# UNITED STATES PATENT AND TRADEMARK OFFICE

APPLICATION NO.	FILING DATE	FIRST NAMED INVENTOR	ATTORNEY DOCKET NO.	CONFIRMATION NO.
10/576,069	02/12/2007	Adrian Podoleanu	742408-9	7422
22204	7590	02/11/2009	EXAMINER	
NIXON PEABODY, LLP 401 9TH STREET, NW SUITE 900 WASHINGTON, DC 20004-2128			COOK, JONATHAN	
			ART UNIT	PAPER NUMBER
			2886	
			MAIL DATE	DELIVERY MODE
			02/11/2009	PAPER

### Office Action Summary

(modified figure 3)

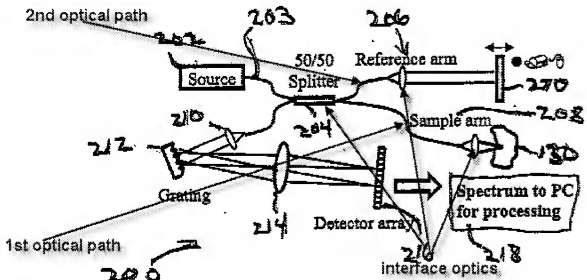
Regarding **Claim 93**, de Boer discloses the aforementioned. Further, a first optical path and second optical path and interface optics are shown (see modified figure 3);

de Boer fails to show a third optical path where the optical output beam from the object are transferred to the displacing means;

However, de Boers does disclose optionally using phase modulators such as acousto-optic, electro-optic, or the like. These would lend themselves to having both the reference and object beam displaced which is an obvious modification that the examiner takes official notice is well known to one of ordinary skill in the art.

Therefore, it would have been obvious to one of ordinary skill in the art at the time of invention to have a third optical path where the optical output beam from the object is transferred to the displacing means because displacing both the reference and

object beam allow for faster stepping of the phase shift between the two and allow for more depth in scanning in an OCT apparatus.
